Quotation Number 1 - Grades between William Burgess and the Judicial Complex

Quotation Number 2 - Subgrade problems in parking areas

PROPOSED  
POND  
EXTENSION

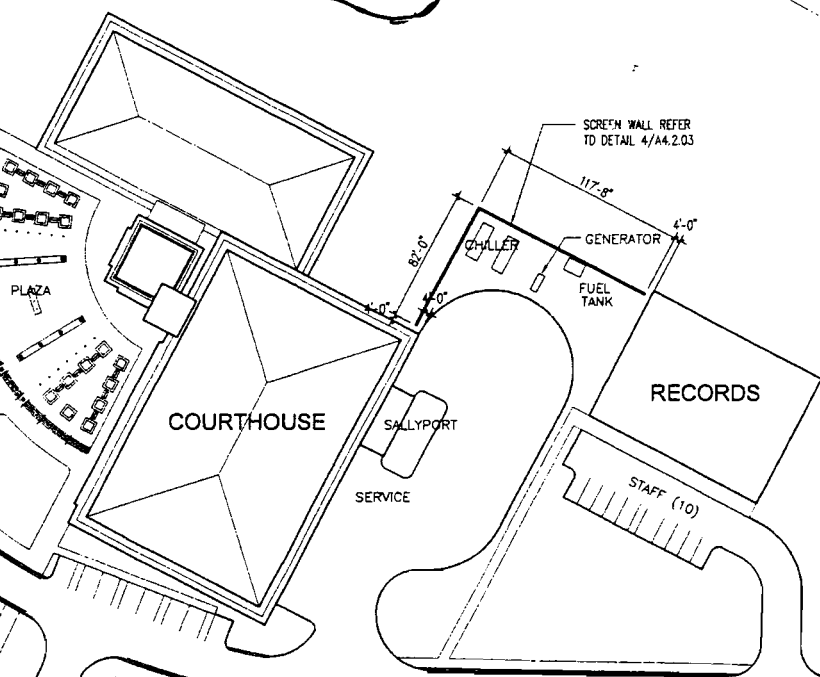
We have been asked to price additional work for the pond extension/grading between the road and buildings. In accordance with the attached drawing, the pond will be extended along William Burgess approximately 90 LF wide by approximately 200 LF by 6 feet deep. The excavated fill will be used to bring the rest of the site up to an appropriate grade.

D6 Dozer: 3 weeks; 120 Hrs @ \$ 80.00/Hr = \$ 9,600.00  
Track hoe & Truck for 2 weeks: 80 Hrs @ \$165.00/Hr = \$13,200.00  
Total = **\$22,800.00 [Not to EXCEED]**

This is in lieu of importing approx.. 1,100 loads of Fill plus spreading to grade - \$90,000.00

**APPROVED** *Quotation # 1 only*
